DEVICE ERRATA

PM4351 COMET

COMET DATASHEET ERRATA

ISSUE 12: OCTOBER 2000

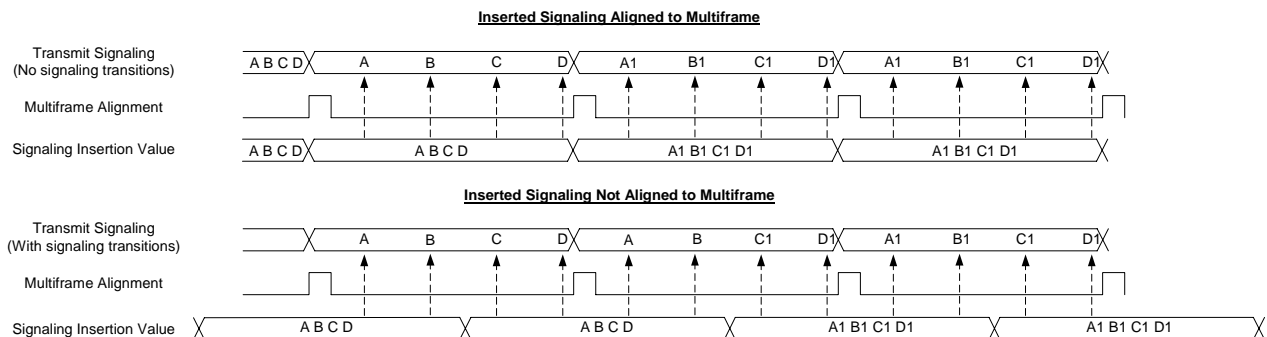
When the COMET is configured for T1 mode with a slaved clock backplane (BRCLK or BTCLK are inputs) with a 2.048 MHz or greater backplane rate, the data and signaling information may be corrupted if the BRCLK, BTCLK, and XCLK jitter (defined as instantaneous worse case period) is not tightly controlled. The following diagram shows the error and error-free operating regions when in the presence BRCLK/BTCLK and XCLK jitter.

The BRCLK/BTCLK jitter is described as the worst case instantaneous peak jitter relative to a jitter-free BRCLK/BTCLK. The XCLK jitter is described as the worst case instantaneous peak jitter relative to a jitter-free XCLK. The jitter for both XCLK and BRCLK/BTCLK are described as positive and negative peak jitter in nanoseconds (ns). Positive peak jitter increases the instantaneous period while negative peak jitter shortens the instantaneous period.

Note that BRCLK and BTCLK are inputs (when the COMET is a backplane slave) and can be 1.544, 2.048, 4.096, 8.192, or 16.384 MHz. If the 4.096, 8.192 or 16.384 MHz clocks are used, they are divided down internally by the COMET to become a 2.048 MHz clock. Thus, internally the period of BRCLK/BTCLK is treated as if it were either a 1.544 or 2.048 MHz clock. The above diagram represents the internally divided down BRCLK/BTCLK clocks.

Proper operation is ensured when the worst case instantaneous XCLK jitter minus the worst case instantaneous BRCLK/BTCLK jitter is less than 2.4ns through all valid voltage and temperature range (XCLK jitter – BRCLK/BTCLK jitter < 2.4). The following are example configurations that allow the COMET to operate error free.

Instantaneous XCLK			Instantaneous BRCLK/BTCLK Range for proper T1 operation		
Frequency ¹ (MHz)	Period (ns)	Jitter ² (ns)	Frequency ³ (MHz)	Allowable Jitter (ns)	Allowable period (ns)
1.544	647.67	+0.6	1.544	> -100	>547.67
1.544	647.67	+0.6	2.048	> -1.8	>486.48
1.544	647.67	-0.6	2.048	> -3	>485.28
2.048	488.28	+0.6	1.544	> -100	>547.67
2.048	488.28	+0.6	2.048	> -1.8	>486.48
2.048	488.28	-0.6	2.048	> -3	>485.28

1. The impact of XCLK jitter is relative to 1.544 or 2.048 MHz.
2. Worse case jitter is the sum of the worst case instantaneous jitter plus the worst case parts per million (ppm) drift from the exact 1.544 or 2.048 MHz XCLK.
3. These examples show that clock jitter is not a significant concern with 1.544 MHz backplane.
